RE: Oldcastle Coastal Facility – 1200 NW 18th St., Pompano Beach, CPTED/Security Public Safety Plan

I have been contracted to review the drawings for security and Crime Prevention Through Environmental Design (CPTED) features in the proposed Oldcastle Bonsal Facility site plan update that is being considered for permitting by the City of Pompano Beach.

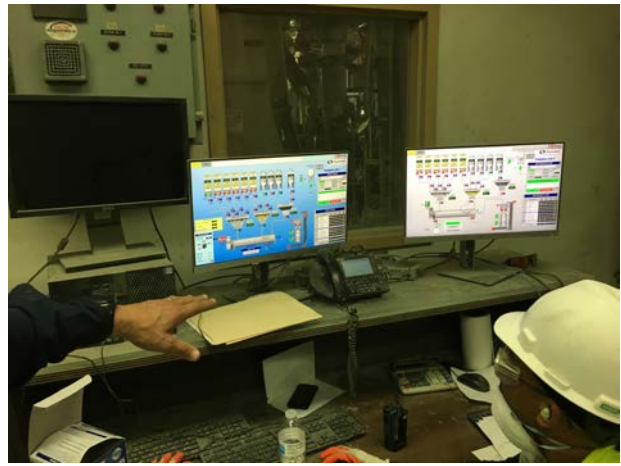
There are several large floodlights on 20-foot light poles positioned randomly in the parking areas to accomplish nighttime lighting. There are floodlights along the warehouse buildings, but the lighting is sporadic, and not up to contemporary lighting standards.

The pole lighting actually uses florescent tubes, and was turned on during daylight hours.

The exterior building lighting is florescent tubes, which are inadequate to properly light the grounds.

The exterior lighting using florescent tubes as the light source was inefficient and not effective to evenly light the site and building exterior.

Perimeter Lighting – The proposed photometric lighting plan will provide adequate lighting for the site and parking areas, without the effects of light trespass or light pollution. On the west and south vehicle entrances light levels are a minimum of 1 footcandle (FC) or greater. The storage yard generally has at least ½ footcandle minimum average coverage. The plant and office buildings will have exterior lighting that illuminate the building exterior in the hours of darkness. It will be important to view any illegitimate activity on the site and around the buildings. Therefore, lighting should be uniform and consistent on the stock and pallet areas with enough lighting to be able to observe movement by any potential trespassers. The exterior showroom areas should have a minimum of ½ FC of lighting to facilitate pedestrian movement and support video surveillance. The plant's renovated lighting is adequate on the east, west and north sides. However, where the silo's are located on the south side, additional luminaires will be added, as there are vehicles parked, stock pallets, and heavy machinery that should be observable.

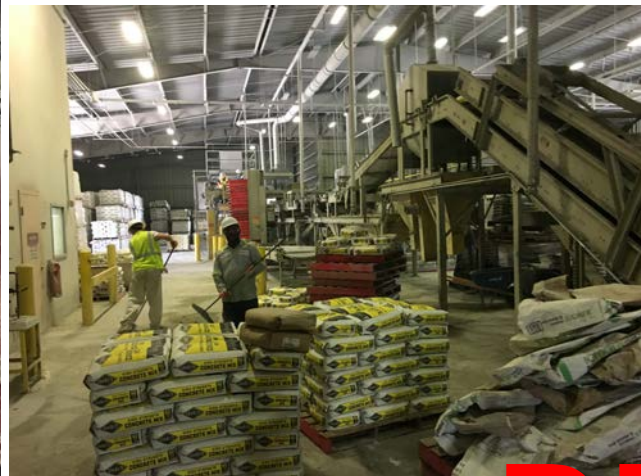
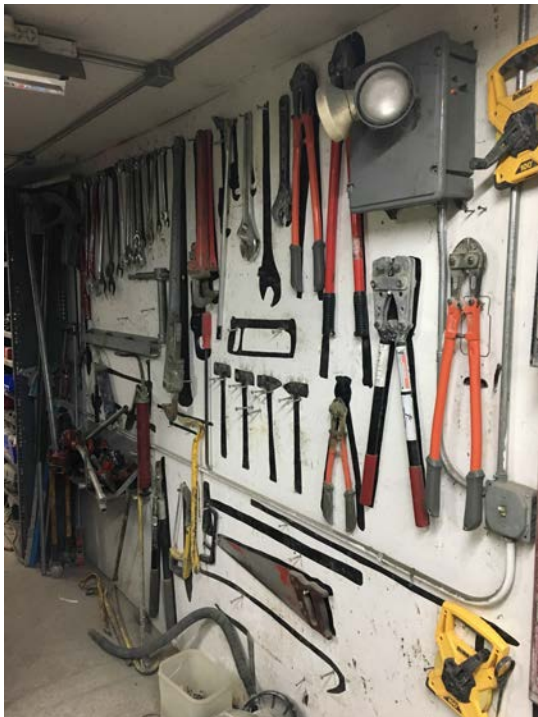
Tools and equipment is an attractive asset that need to be protected.

Forklifts and product stacked are assets that need to be protected.

Tools and machinery must be protected from loss, theft, pilferage, or vandalism.

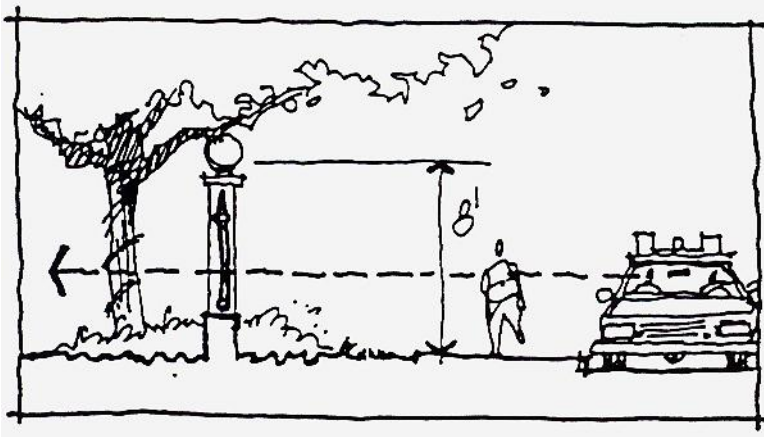
The west border definition will be improved with an attractive picket metal code compliant fencing with plantings, and a vehicle gate. It is recommended that as the site is improved to accommodate a sidewalk connection, and new monumental sign, and additional stripping at the entrance of onto Andrews Avenue will be added to direct the heavy trucks and rigs.

The approach onto the site will remain open because of the volume of traffic by trucks and rigs picking up and dropping off product, While the gates remain open during plant operations, there is the capability to secure the site and close the manually operated gates when there are holidays.

The pictures above are examples of vehicle gates and creating a secured entrance for company deliveries and vehicles.

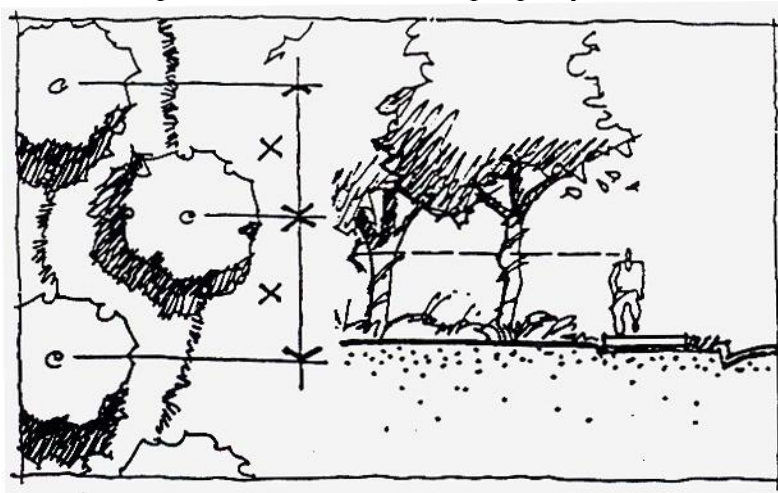
Natural surveillance – Natural surveillance is accomplished on the site by having a chain link fence on the north, south, and east boundaries. The west side boundary is being proposed to have decorative attractive code complaint decorative fencing and vehicular gates to create an entrance that allows open visibility by employees and staff and video surveillance. Police patrol will be able to readily discern any inappropriate or suspicious activity on the exterior of the fence, and see over the low shrub boundary, and under the tree canopies.

Ground plantings and hedges should be less than 3 feet and tree canopies over 8 feet to allow a clear zone of natural surveillance for police to be able to have un-obscured sight around the perimeter and into the property.
